Fayette
COUNTY

**Subject: Addendum #1 for Invitation for Bids #917 Fayette Senior Center
Expansion**

PROJECT: FAYETTE SENIOR CENTER EXPANSION
4 Center Drive
Fayetteville, GA 30214

Architect: HARRIS FRITZ & ASSOCIATES, INC.
141 South Avenue
Marietta, Georgia 30060 Arch. Project No. 2014-009

E-3

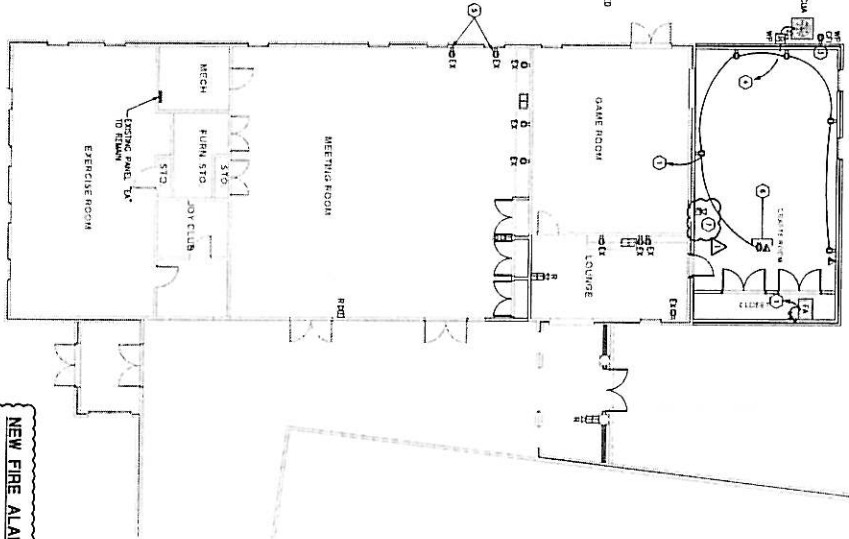
2. **Cover sheet mentions that existing building has an integrated fire alarm/sprinkler system. Is this system to be expanded into the new addition?** Yes. Please see Architect attached response and revised sheets showing the alarm/sprinkler work that is to be priced by each contractor.

SHEET E-3
Revised 1-9-2015
Revision showing fire alarm in building addition and notes.
